PRODUCT BULLETIN # 20233

Issue Date: 13-Sep-2013

TITLE: Change SOD123-FL Package Maximum Height

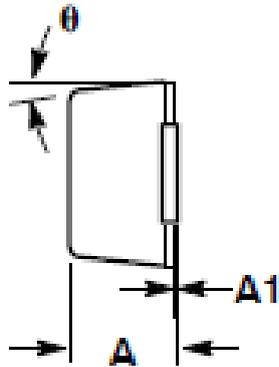
ON Semiconductor is notifying customers of its plan to change the maximum height of SOD-123FL package from 1mm to 0.98mm at SBN, Malaysia manufacturing site.

The mold compound, die attach, and lead frame materials used in the SOD-123FL package will remain the same. Qualification was done and CPK calculated to be passing for the new package height limit.

Comparison for Old and New Case Outline

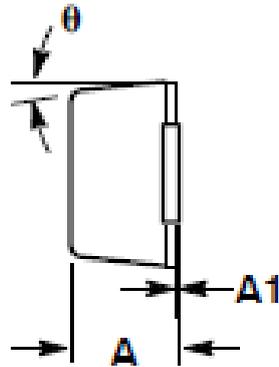
Old

New

| DIM | MILLIMETERS | | |
|-----|-------------|------|------|
| A | 0.90 | 0.95 | 0.98 |
